水務署
Water Supplies Department

檔號
Reference (4) in WSD 3321/2026 T/J(335/2026)

**Approval of "TOTO" Flush Valve
(General Acceptance No. ZC20260412F)**

Details of Fitting: 2" Plastic dual flush valve

WH142B-T1

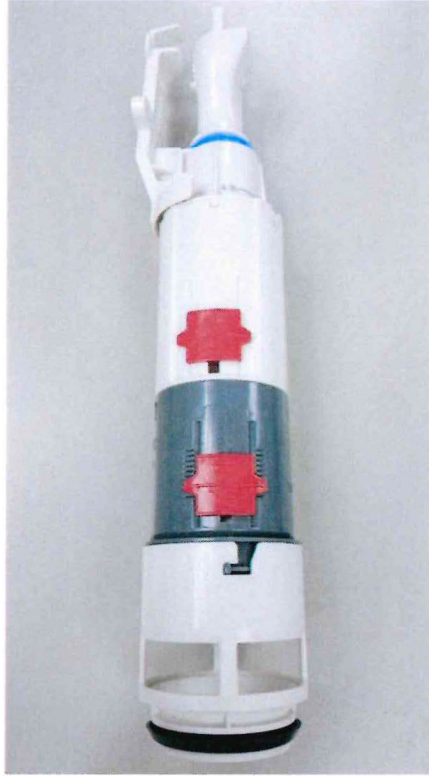
As the fitting has not been tested for use in contact with water intended for human consumption, the fitting can only be used in flushing water plumbing systems.

"The flushing volume of the flushing valve should be adjusted to suit the design of the toilet bowl so that wastes can be cleared effectively by a single flush."

"The fitting should be used within the range of working pressures specified by the manufacturer." AND

"The installed fitting should not result in backflow of water that will contaminate the flushing water supply."
